Proposed Revisions to a Standard Plans Index

Index Number: 455-440

Index Title: Precast Concrete Sheet Pile Wall (CFRP/GFRP & HSSS/GFRP)

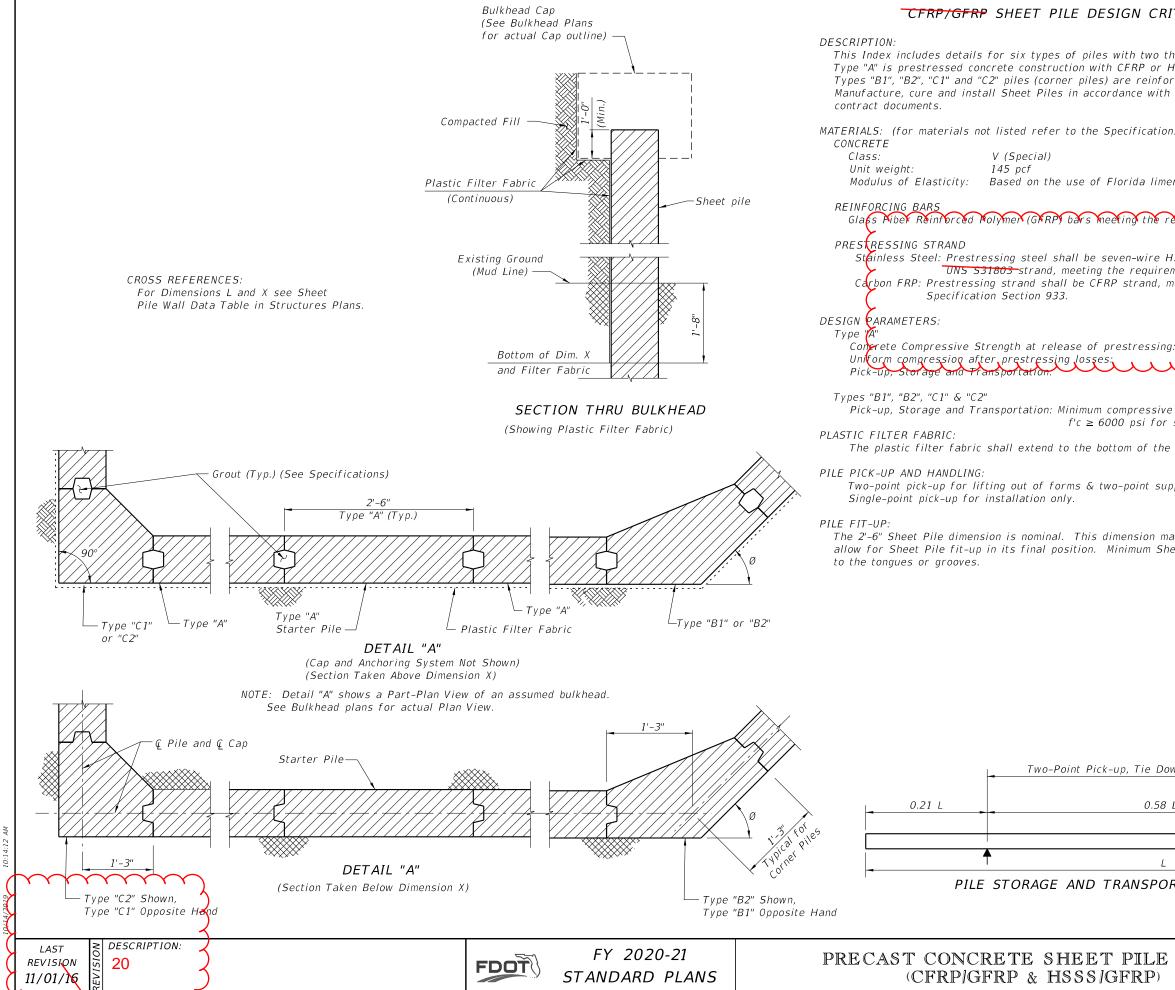
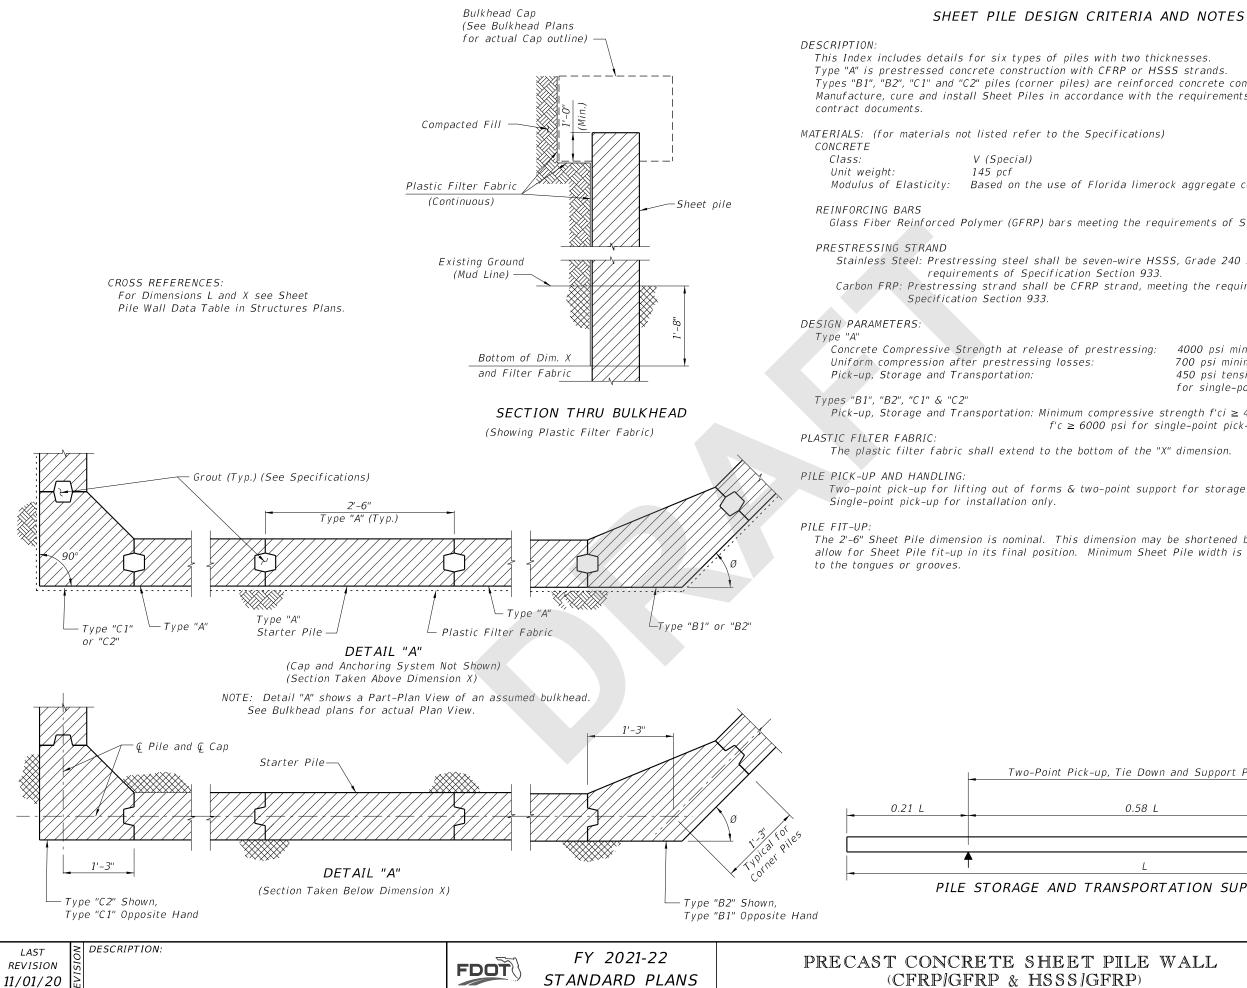
Changed Prestressing Strand SS Note

New criteria for HSSS strand

thicknesses.				
HSSS strands. Forced concrete construction. th the requirements of the				
ions)				
nerock aggregate concrete				
requirements of Specification Section 932.				
HSSS, Grade 240 strand, me 933. meeting the requirements of	eting the			
ng: 4000 psi minimum 700 psi minimum 450 psi tension with 1.: for single-point pick-up				
ve strength f'ci ≥ 4000 psi re pr single-point pick-up.	equired for tw	o-point pick-up;		
he "X" dimension.				
upport for storage & transportation.				
may be shortened by the Manufacturer up to $\frac{1}{2}$ " to Sheet Pile width is 2'-5 $\frac{1}{2}$ ". No changes shall be made				
Down and Support Points	-	Single Point Pick-up		
8 L	0.21			
L				
ORTATION SUPPORT DETAILS				
	NOTES AN	D DETAILS		
E WALL	INDEX	SHEET
